PRODUCT CHANGE | Crown Adapter 35mm Motor in 45mm Crowns

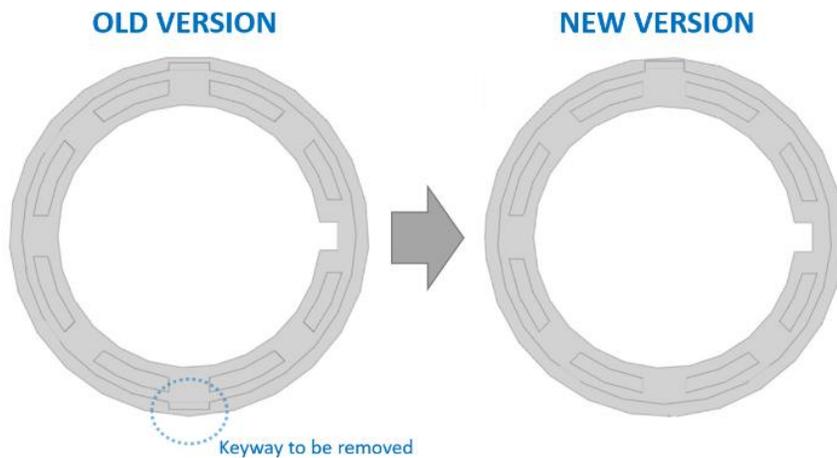
- The lower of the 2 keyways was removed from the design of this crown adapter
- This change allows the crown adapter to properly interface between 35mm motors and crowns for 2.5", 3.25", 60, and 80mm tubes
